## PRODUCT / PROCESS CHANGE NOTIFICATION

1.1 Company	 STMicroelectronics International N.V
1.2 PCN No.	MDG/24/14653
1.3 Title of PCN	ST MUAR (Malaysia) Conversion from Matrix to Super High Density (SHD) leadframe for STM8Lx and STM8Sx listed products in LQFP 14x14 80L/64L package.
1.4 Product Category	STM8S207x, STM8S208x, STM8L151x, STM8L152x, STM8L162x.
1.5 Issue date	2024-07-15

**PRODUCT/PROCESS  
CHANGE NOTIFICATION  
PCN14653 – Additional information**

**ST MUAR (Malaysia) Conversion from Matrix to Super High Density (SHD) leadframe for STM8Lx and STM8Sx listed products in LQFP 14x14 80L/64L package.**

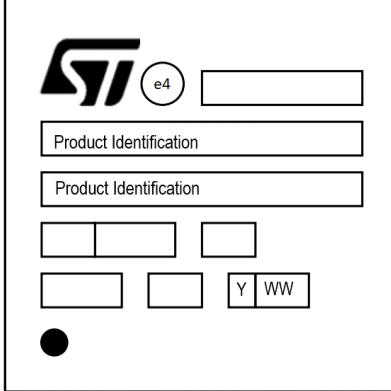
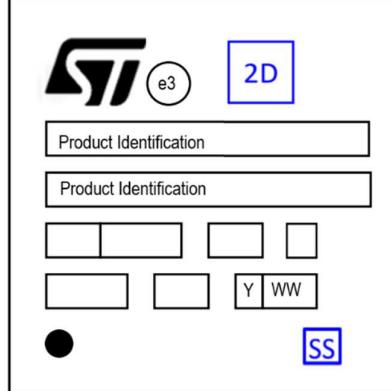
Current back-end lines	New back-end line
Assembly site	ST Muar (Malaysia)	
wire	Gold 1.0 mil	Silver 0.8 mil
Leadframe	Matrix	Super High Density
Leadfinishing	NiPdAu, preplated (e4)	Ring Ag, postplated (e3)
Resin (1)	Sumitomo G700L	Sumitomo G700LS
Glue	LOCTITE ABLESTIK 3280T	Hitachi EN4900GC
Enhanced Traceability in marking	No digit	2 digits SS marking 2D marking

**(1)** Package darkness changes depending on molding compound.

Pin1 identifier can change in terms of form and positioning.

Marking position and size could be different depending on the assembly line, without any loss of information.

Impacted Package	Current marking composition Example	New marking composition Example
LQFP64 14x14	 No Digit	 With Enhanced Tracability (2D & SS) marking
LQFP80 14x14

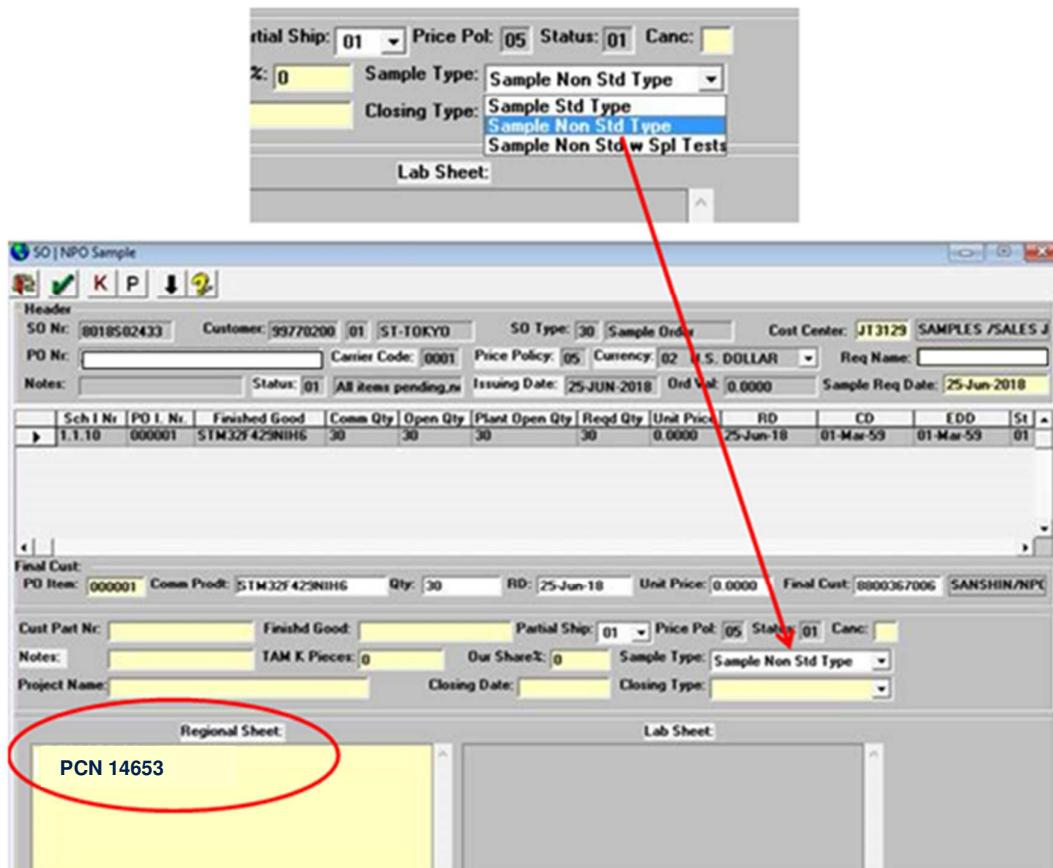
**Y WW code:** Year Week (manufacturing date)

**PP** code indicates the Assembly traceability plant code.

PP code	Assembly Line - Fab
99	ST Muar (Malaysia)
